528 BOYLSTON STREET URBAN DESIGN REVIEW

July 24, 2023

Landscape Plan

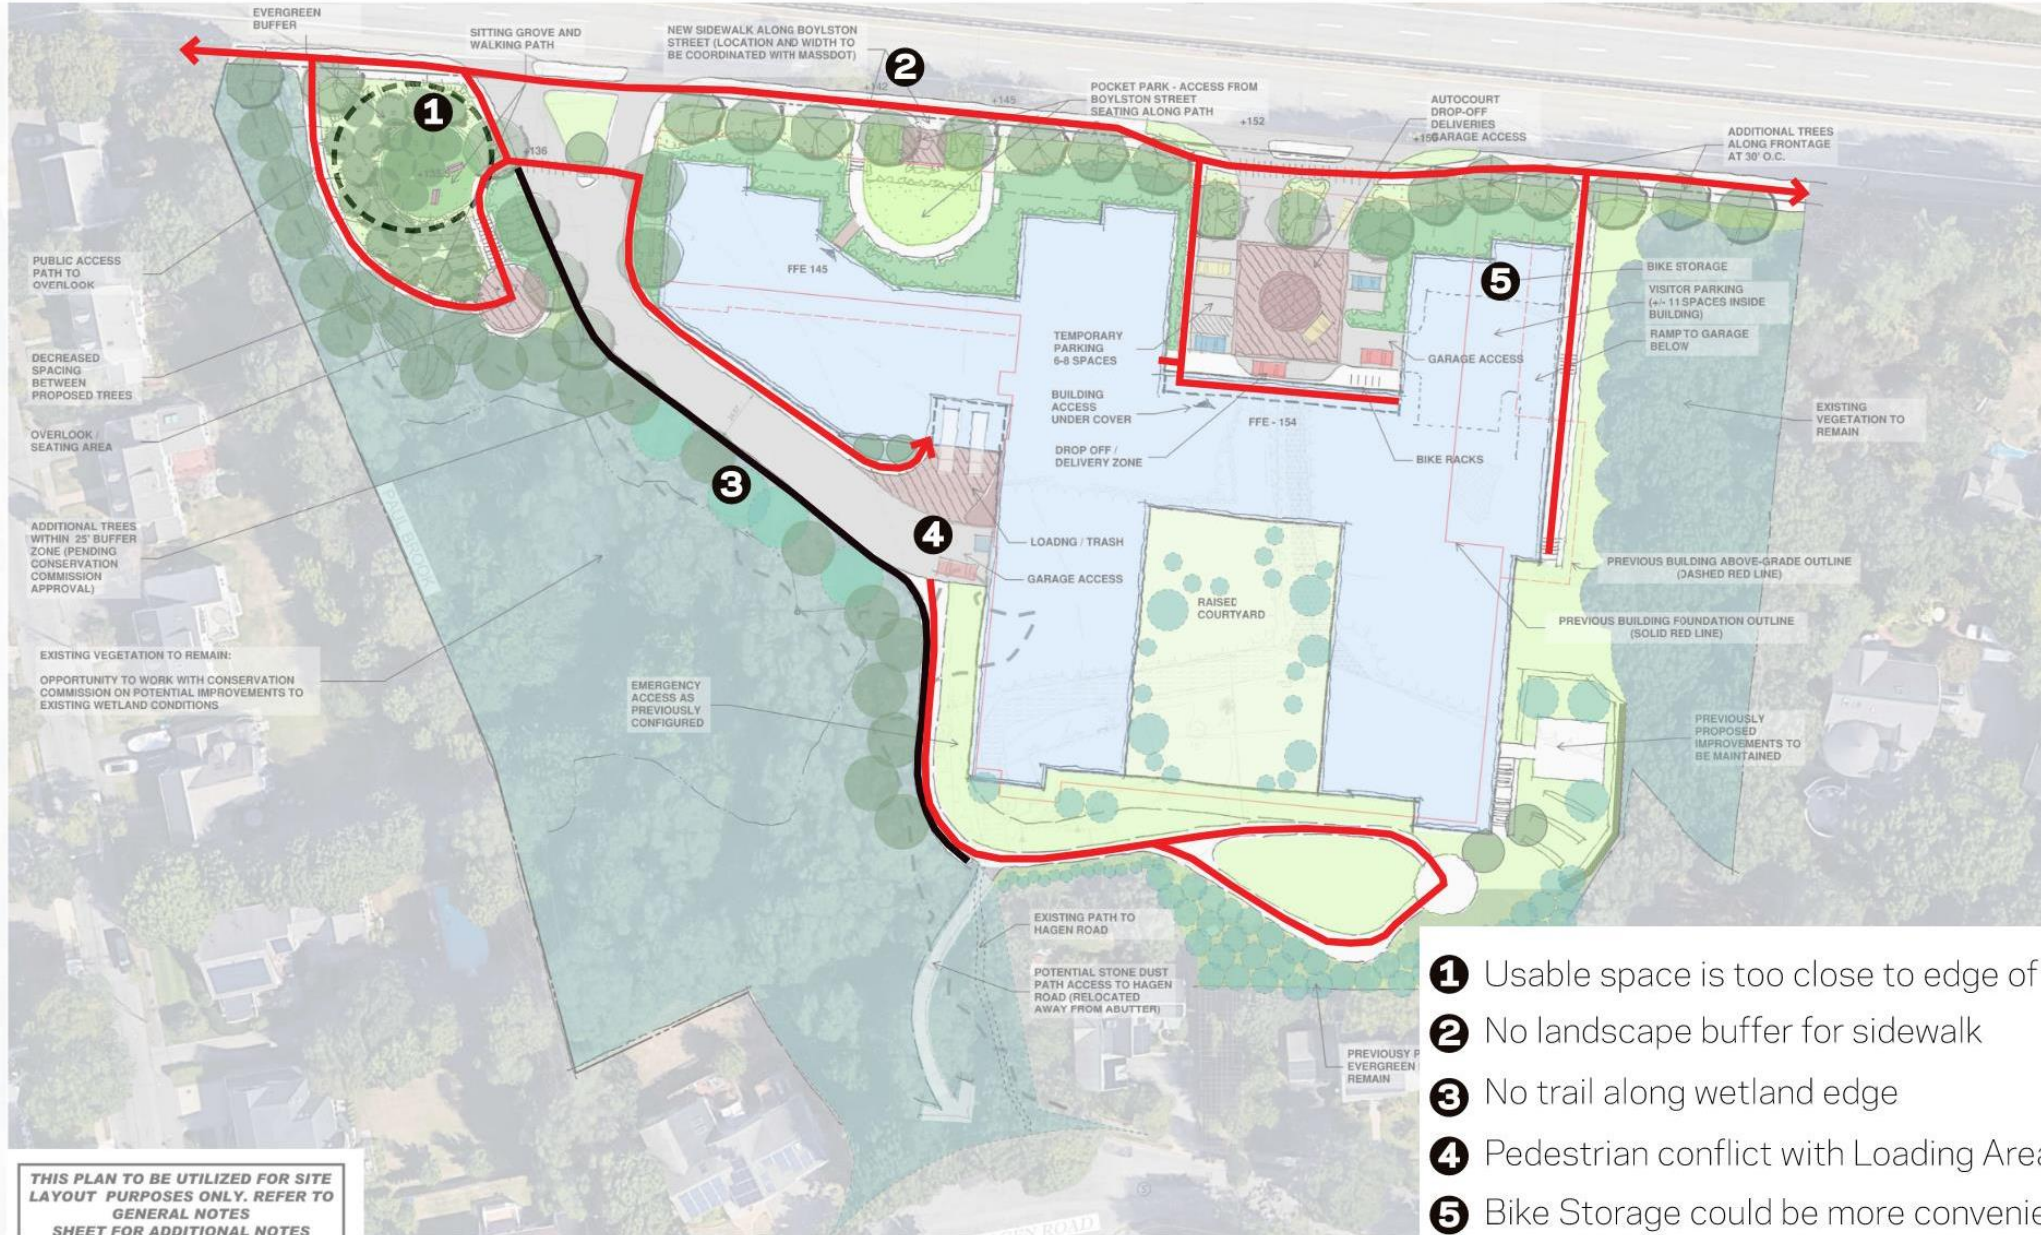
Reconsider the location of a **pocket park along Boylston Street**. The noise and pollution from the roadway will limit the functionality of a park at this location unless significant steps are made to buffer pedestrians. This could include grade changes, low walls, additional landscaping, or small structures that can shield the roadway.

Consider making a strong **north-south linear park** that connects Boylston Street to Hagen Road. This could include a 10'-12' wide continuous multi-use path for both pedestrians and bicyclists, providing a safe connection to community facilities including Newton South High School. Additionally, gateway and interpretive signage could be included to further improve the accessibility and functionality of the space – one that can be enjoyed by both residents and the surrounding community.

Enhance Paul Brook and the existing conservation land by **removing invasive species** and providing greater accessibility (ex: boardwalks and interpretive signage).

Provide additional information on the design of the proposed open spaces, including retaining wall details, paving materials, plant materials and quantities, signage, and lighting. Additionally, we request that the applicant provide detailed site sections (including the Boylston Street frontage) and 3d ground level vignettes.

During our site walk we noticed **beautiful rock outcrops** on the east side of the site. Can some of these outcrops be preserved and/ or featured in the landscape design?

Bike and Pedestrian Circulation

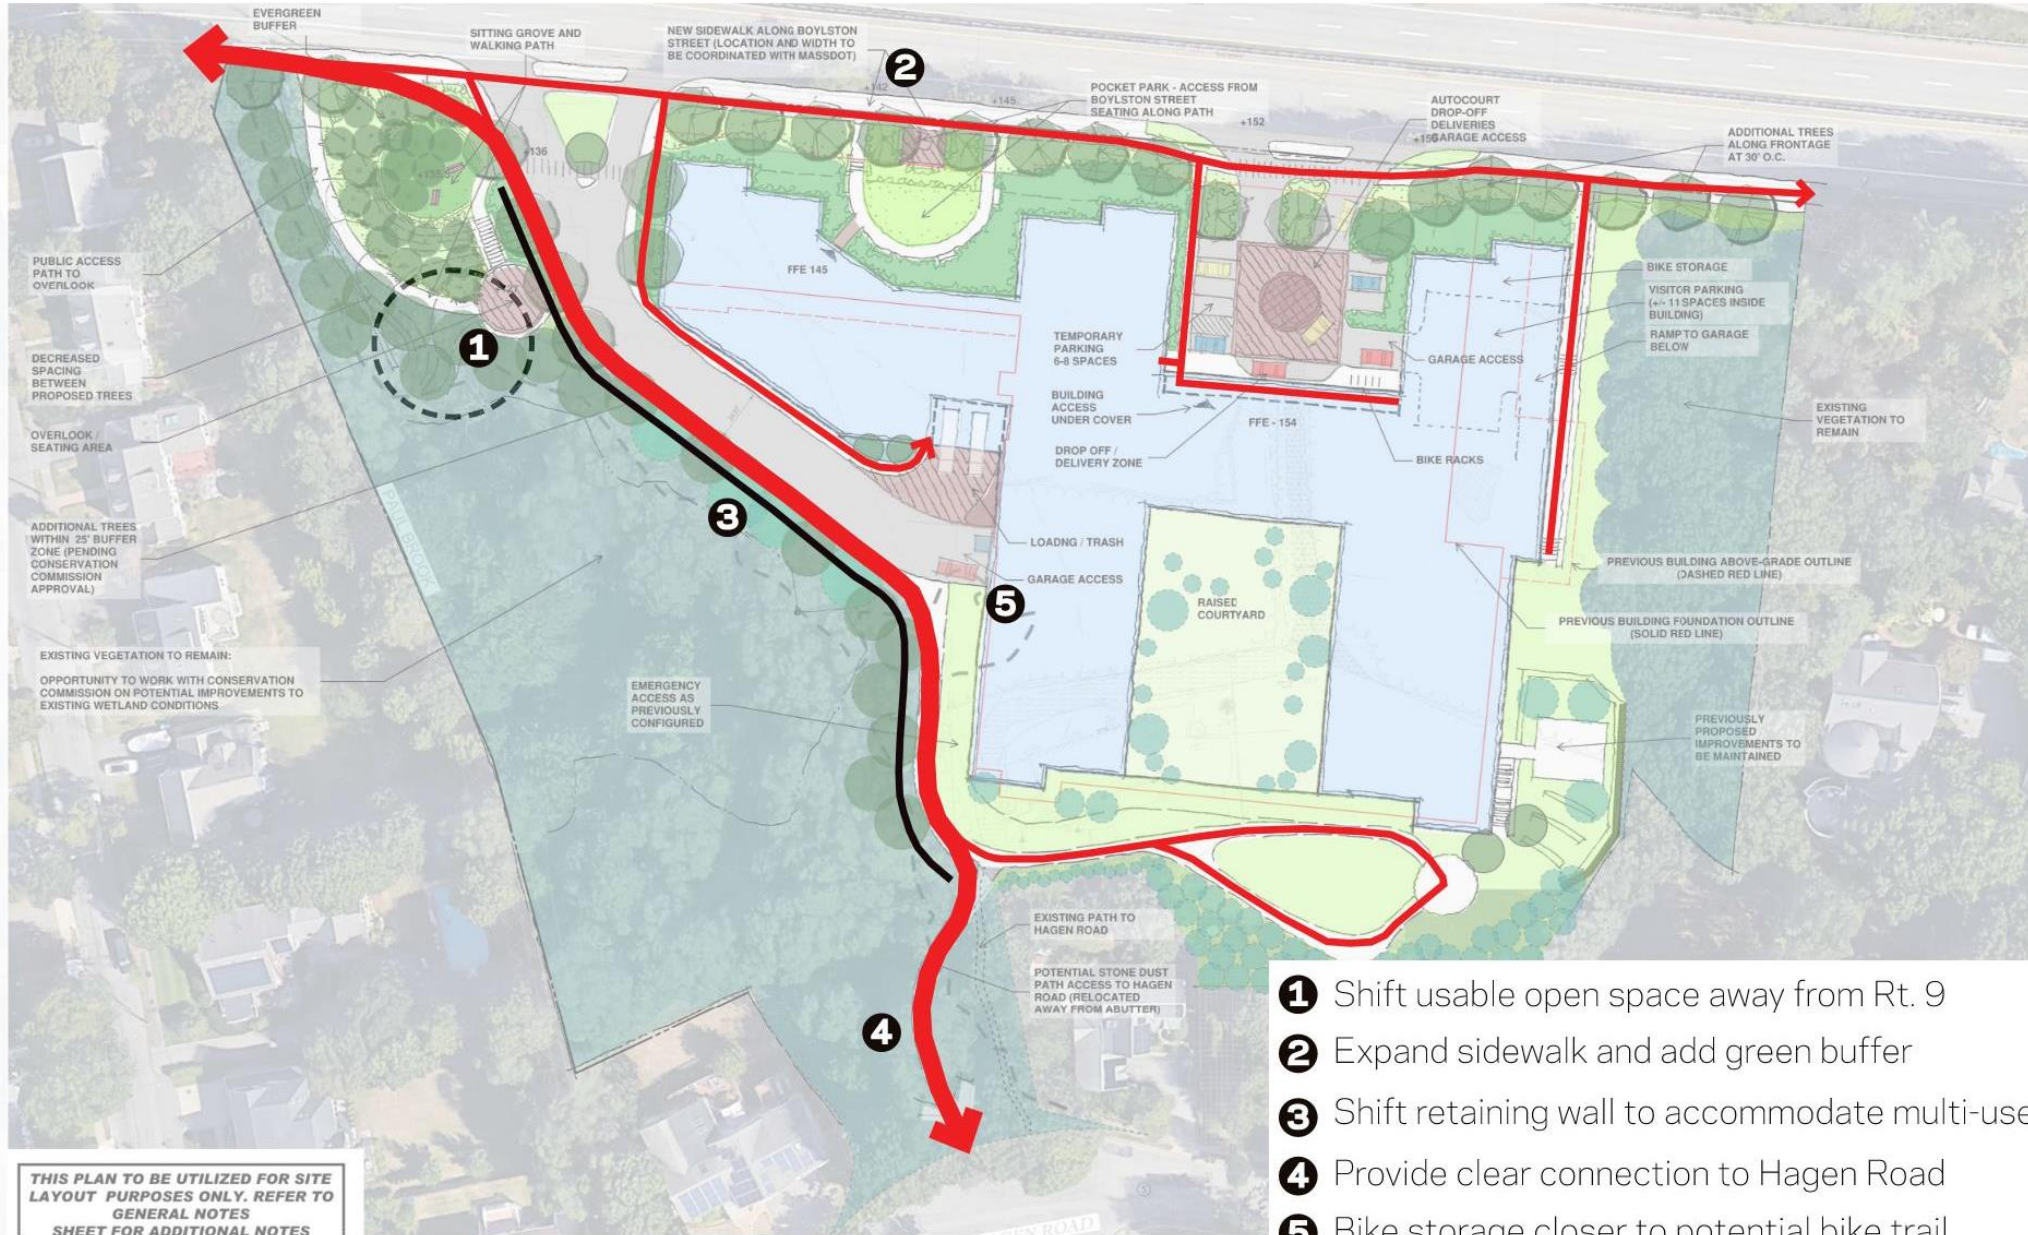
- 1 Usable space is too close to edge of Rt. 9
- 2 No landscape buffer for sidewalk
- 3 No trail along wetland edge
- 4 Pedestrian conflict with Loading Area
- 5 Bike Storage could be more convenient

Location of Service and Parking Entrances

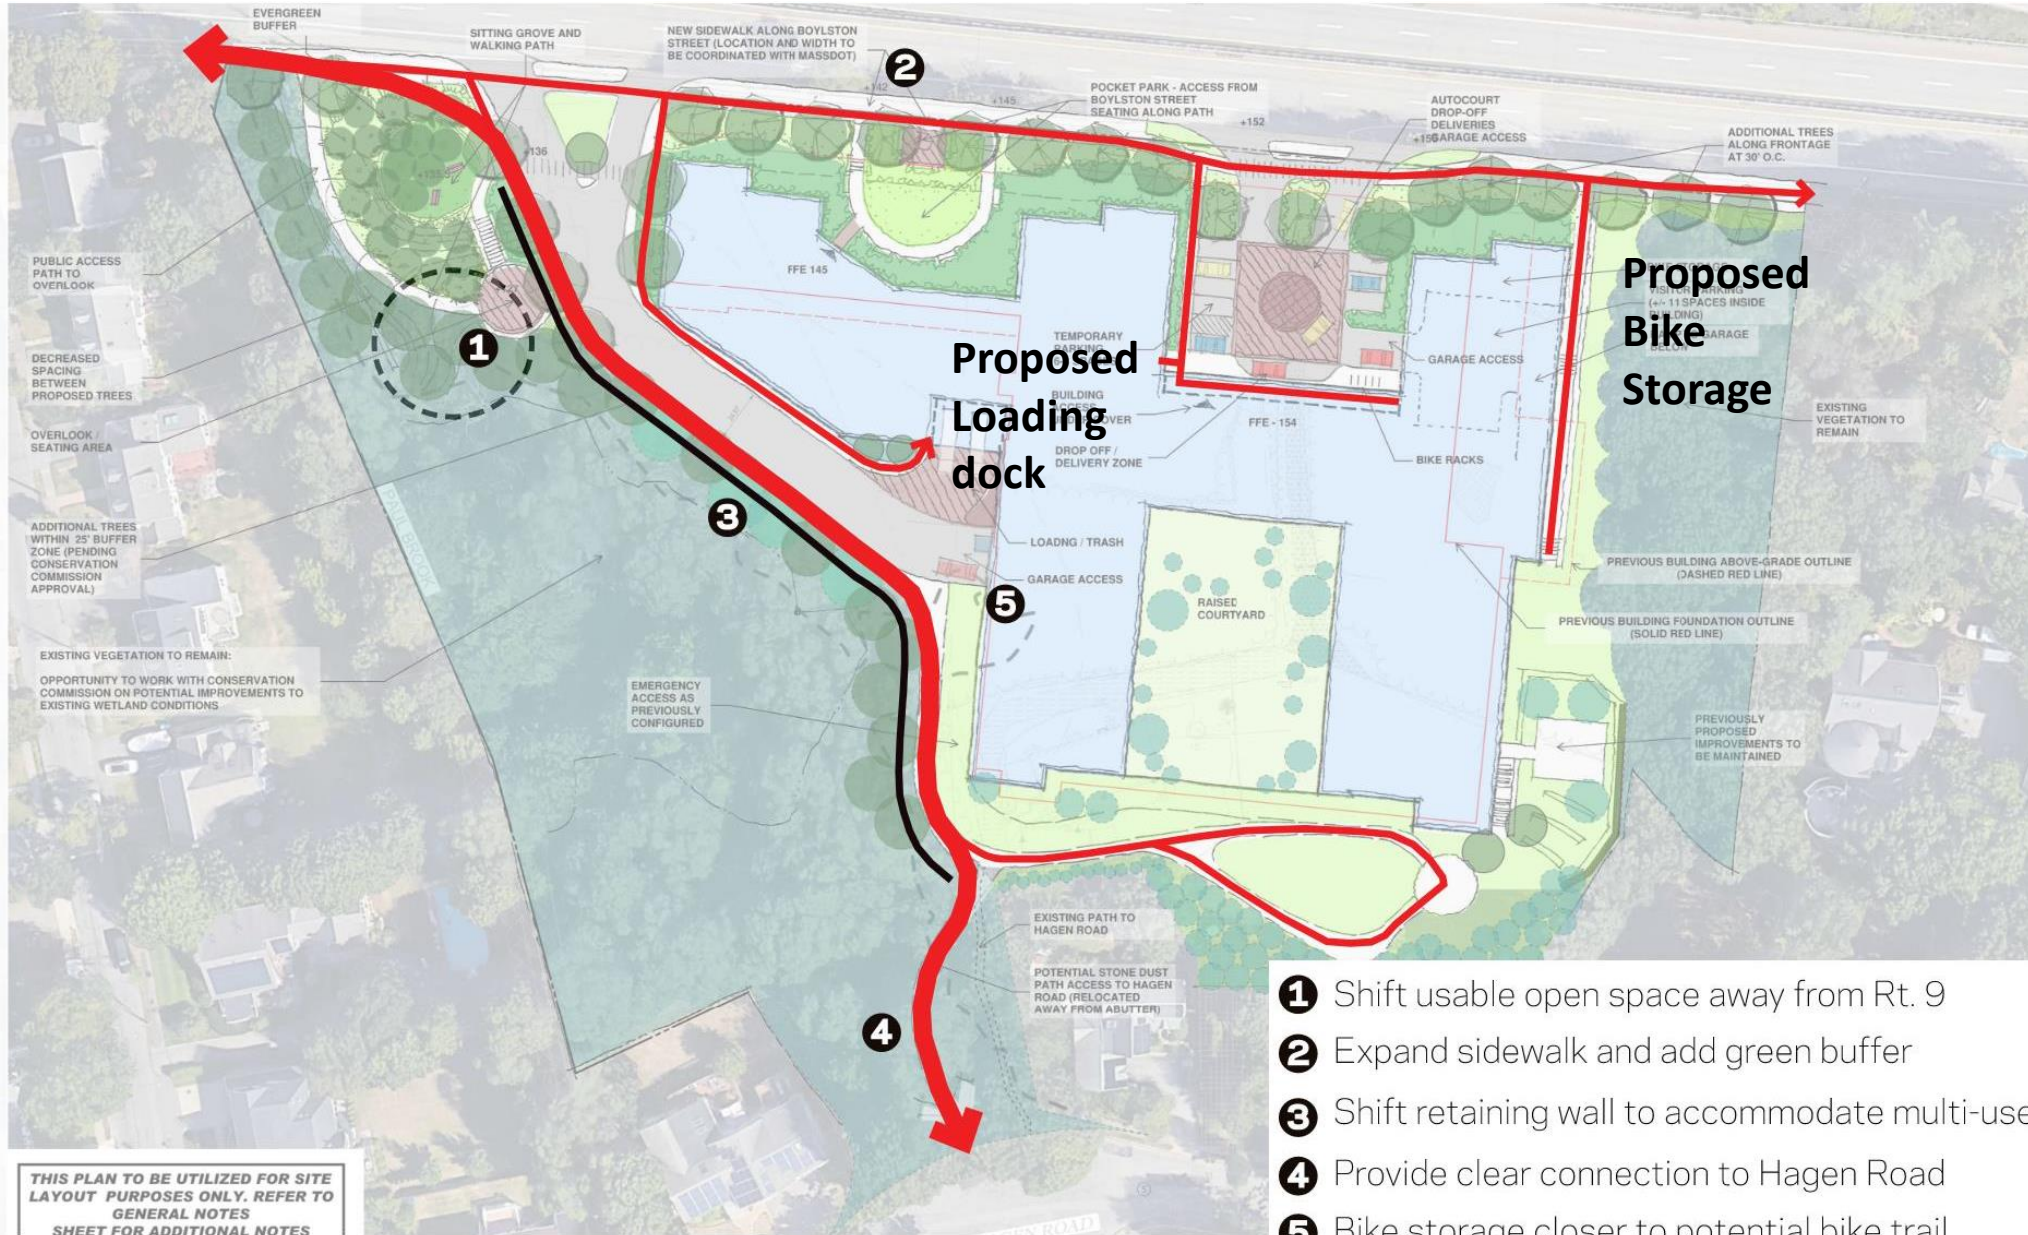
The revised design submission includes an additional parking entrance adjacent to the new drop-off area along Boylston. We think that this additional entrance provides functionality (allowing someone to drop off someone at the main entrance and then go directly into the garage without needing to get back onto Boylston Street). It may also better distribute the traffic volume across the site. However, this new configuration requires two curb cuts along Boylston Street rather than the single point of entry in the initial proposal. We recommend that the traffic engineer provide additional analysis to verify that there will be no additional safety concerns for vehicles or pedestrians.

The loading dock for the project is located at the back of the building adjacent to one of the parking garage entries, minimizing the impact on Boylston Street. We request that the applicant provide a truck turning study along with additional information that highlights how noise and lighting associated with the loading area will be mitigated to protect abutting single-family homes.
